In the Drawings:

REMARKS

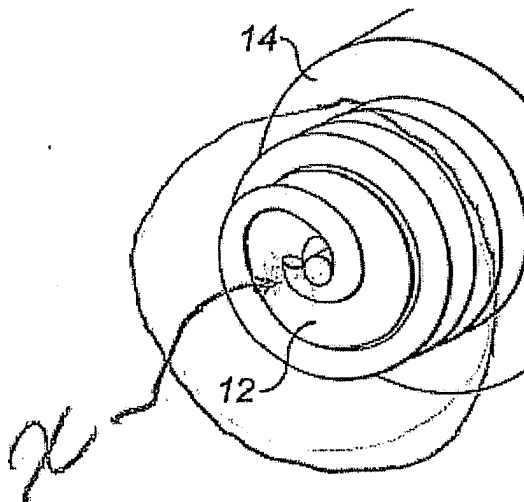
Claim 1 makes it clear that the wire is insulated. Thus the wire is distinct from the insulation. It is the wire and not the insulation that has to be uniform. The prior art, as illustrated below, shows a point of non-uniformity at the "X". Thus the prior art does not anticipate claim 1.

To further clarify and distinguish over the art applicant has amended claim 32 to recite that a seamless conductor forms a coil and central conductor. As shown at the "X" the prior art wire is not seamless.

To further clarify and distinguish over the art, applicant has amended claim 23 to make it clear the coil 22 and central conductor 24 are a single homogenous conductor.

Fig 2.

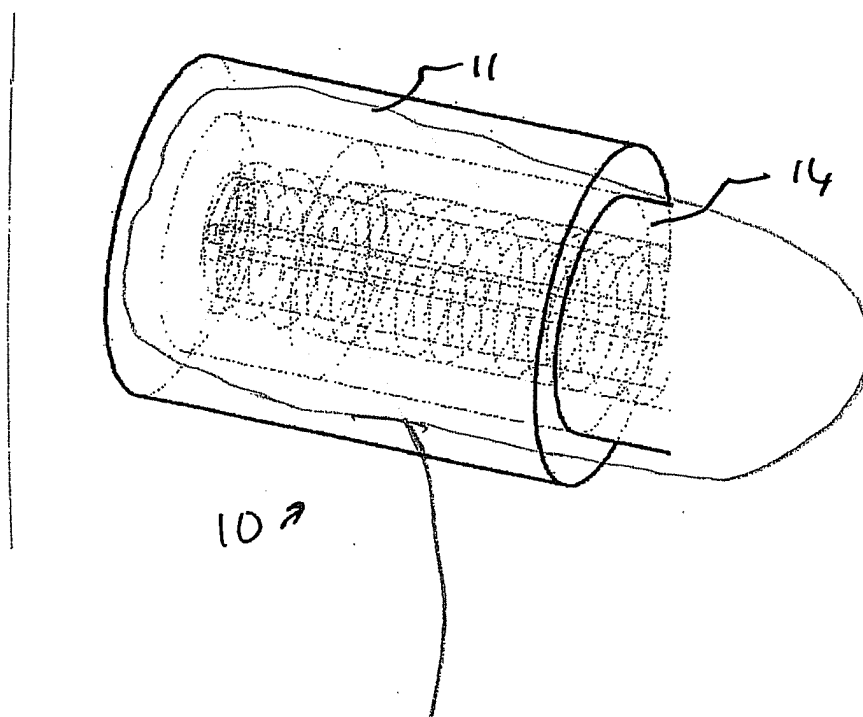
Applicant submits herewith Replacement sheet 1/2. The sheet replaces original sheet 1/4 and 2/4. Figs. 1 and 2 on Replacement Sheet 1/2 were labeled prior art. Reference numbers 18, 10 and 16 have been removed from Fig. 1. Reference number 10 has been removed from Fig. 2. Additionally, the coiling and internal structure shown in original Fig. 2 has been clarified. A marked sheet showing where the coiling and internal structure has been clarified, is attached to the action.

item clarified
